Geotechnical Letter

Atlas No. 170446P4-6
Report No. 6

**Subject: Response to Geology Issues
Fairmount Avenue Fire Station
47th Street and Fairmount Avenue, San Diego, California**

GEOTECHNICAL MAP

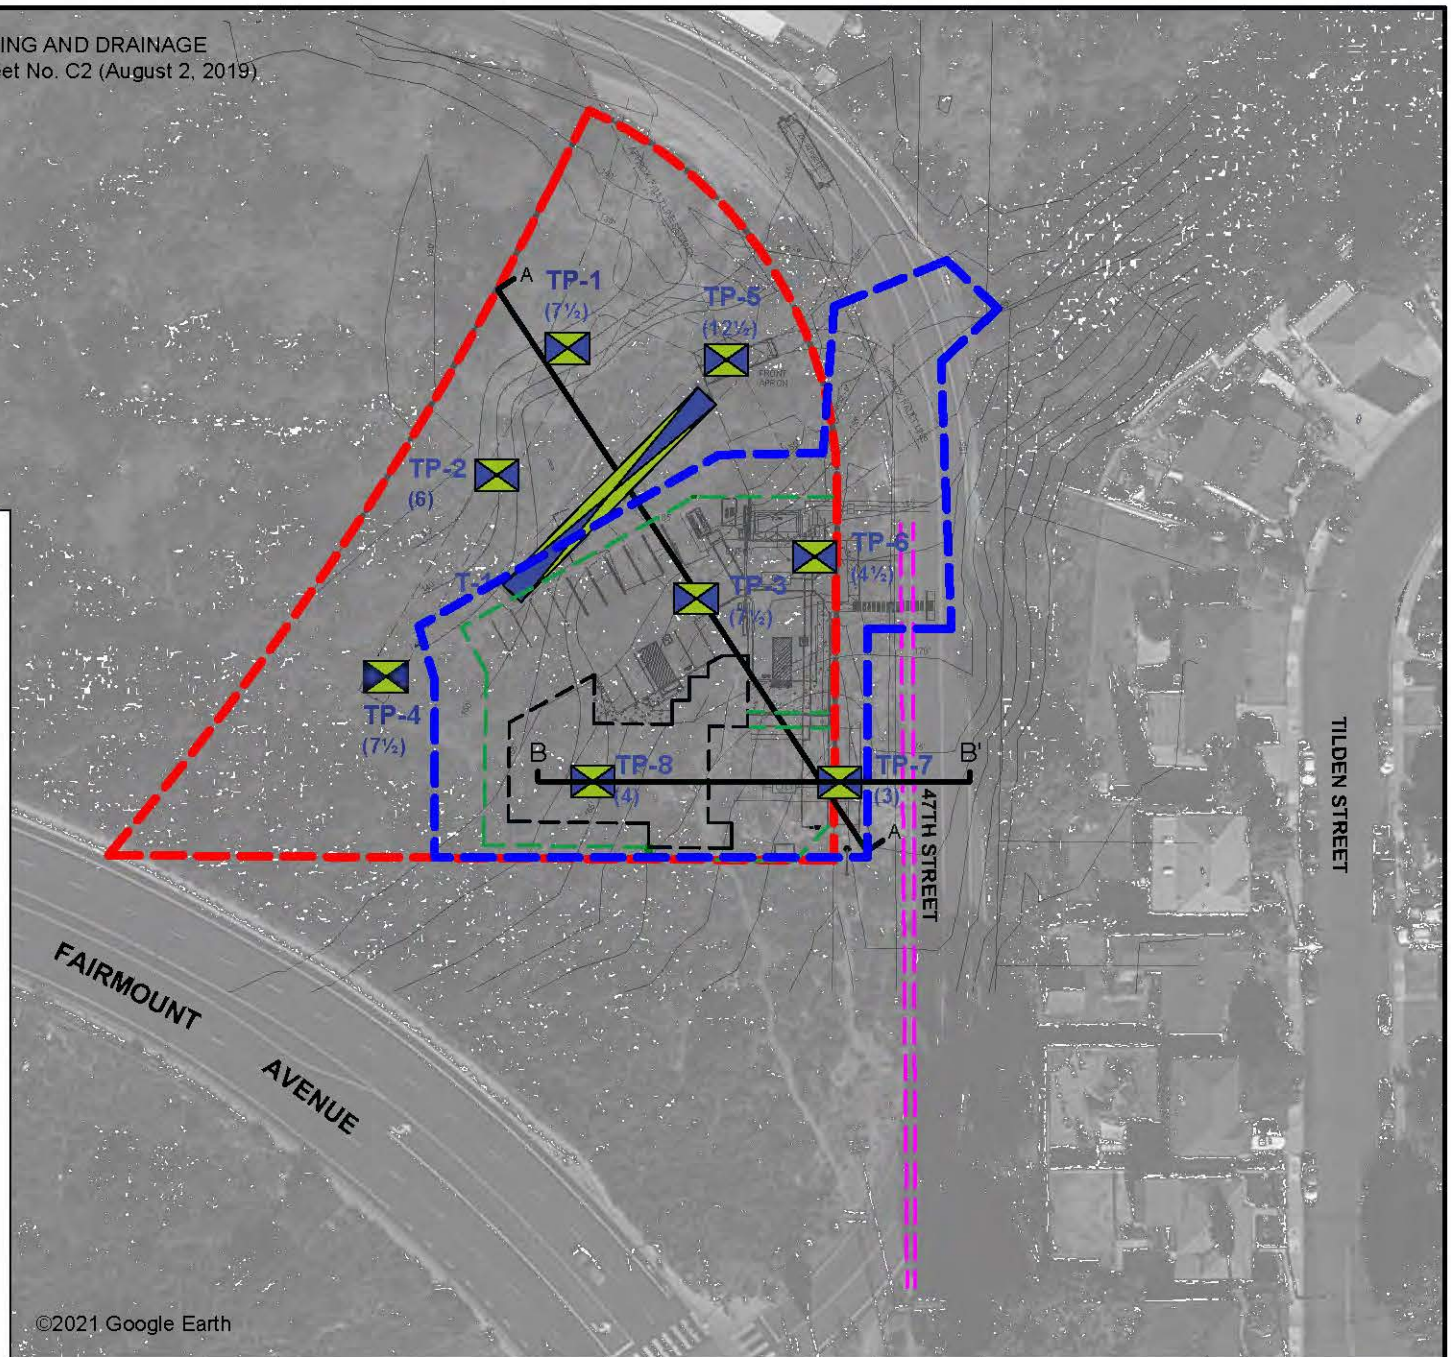
Issue No. 15: *The project's geotechnical consultant should show the location of the high-pressure gas main on an updated site specific geologic/geotechnical map.*

Response: The 20-inch high-pressure gas main and 4-inch gas line are shown on the attached geotechnical map (Figure 1).

GEOLOGIC CROSS-SECTION B-B'
Fairmount Avenue Fire Station
San Diego, California

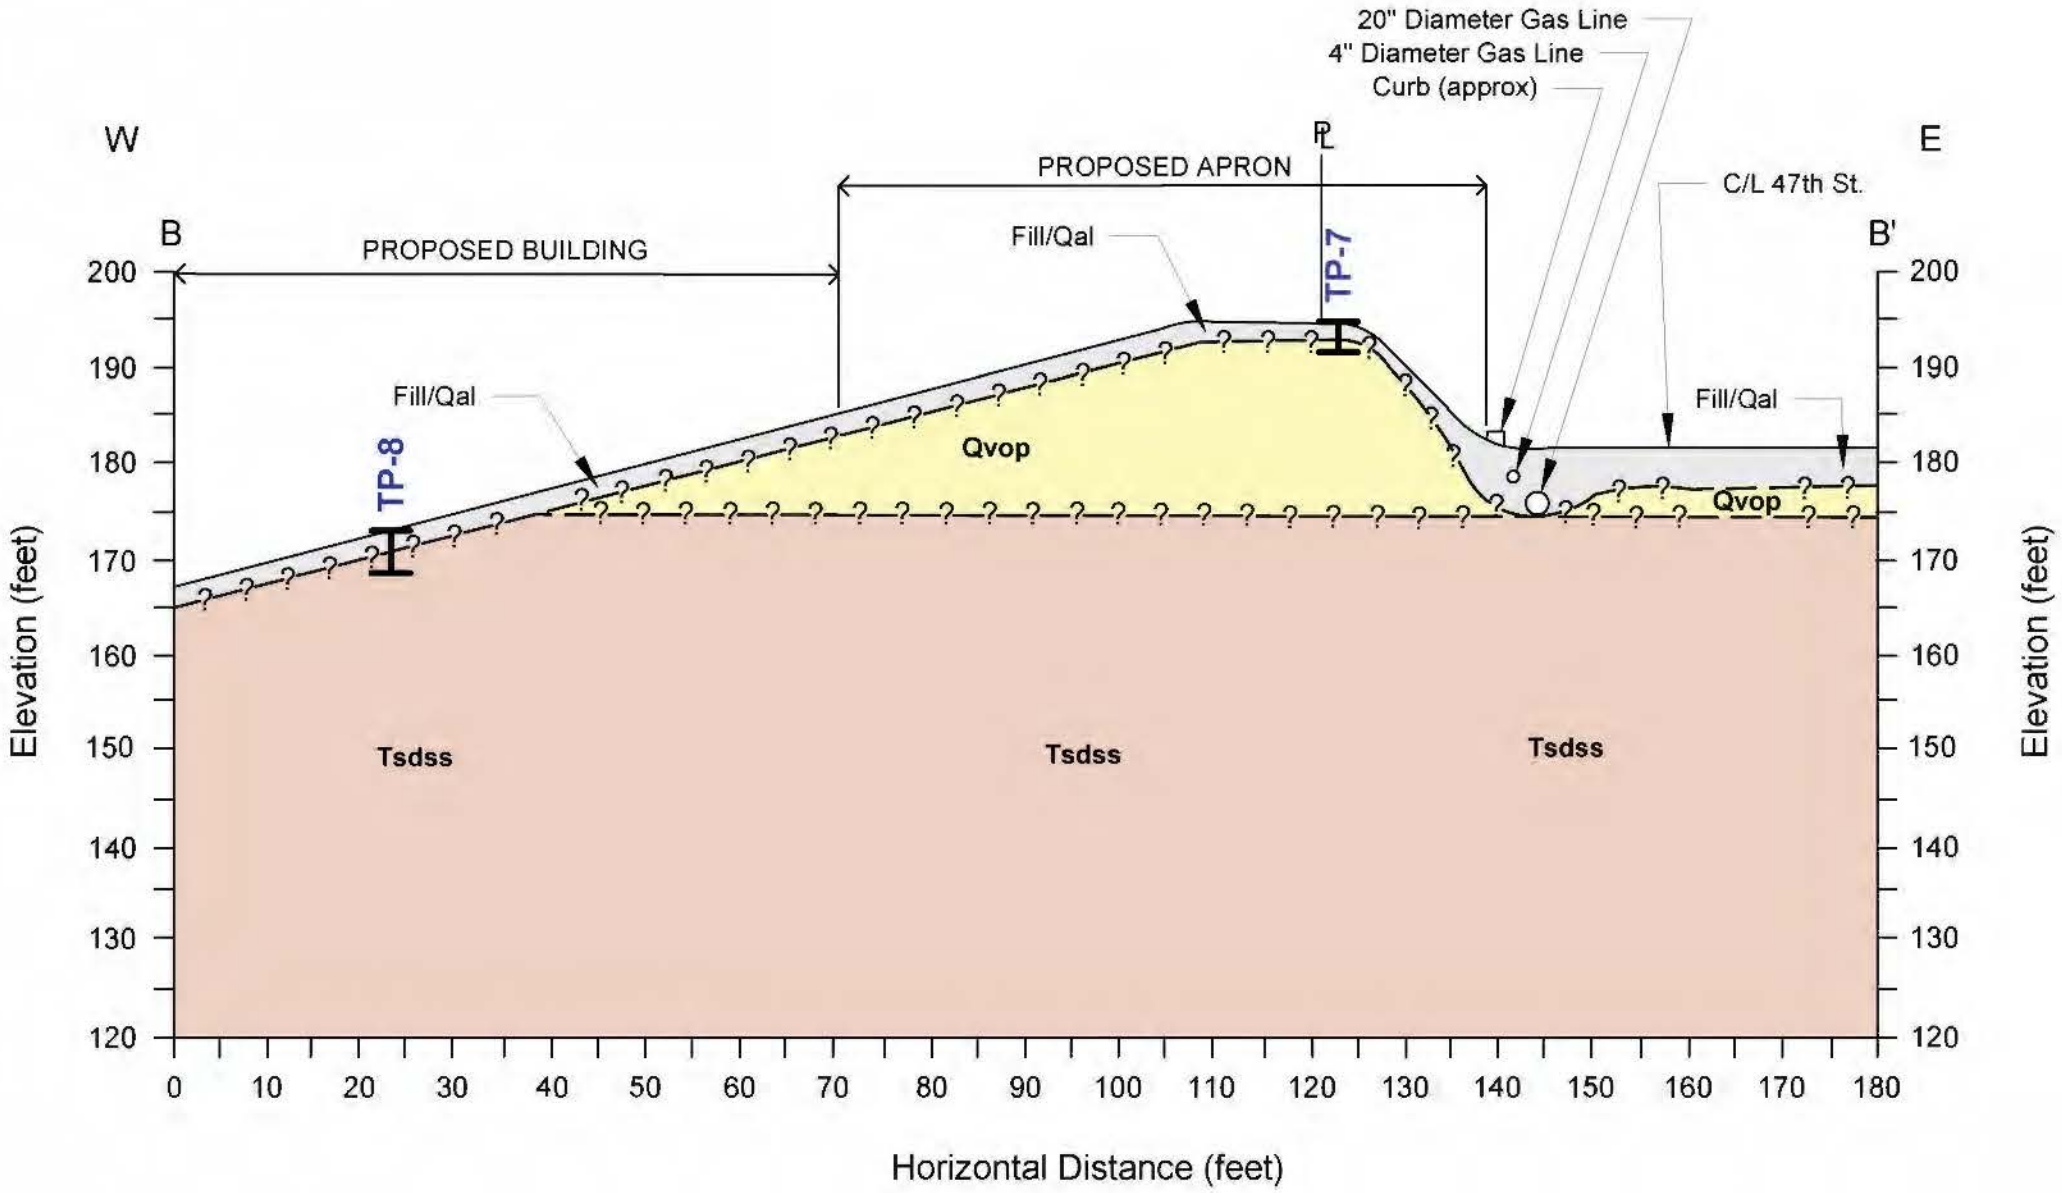
Issue No. 16: *The project's geotechnical consultant should show the location of the high-pressure gas main on updated representative geologic/geotechnical cross-sections.*

Response: The 20-inch high-pressure gas main and 4-inch gas line are shown on the attached cross section (Figure 2B).
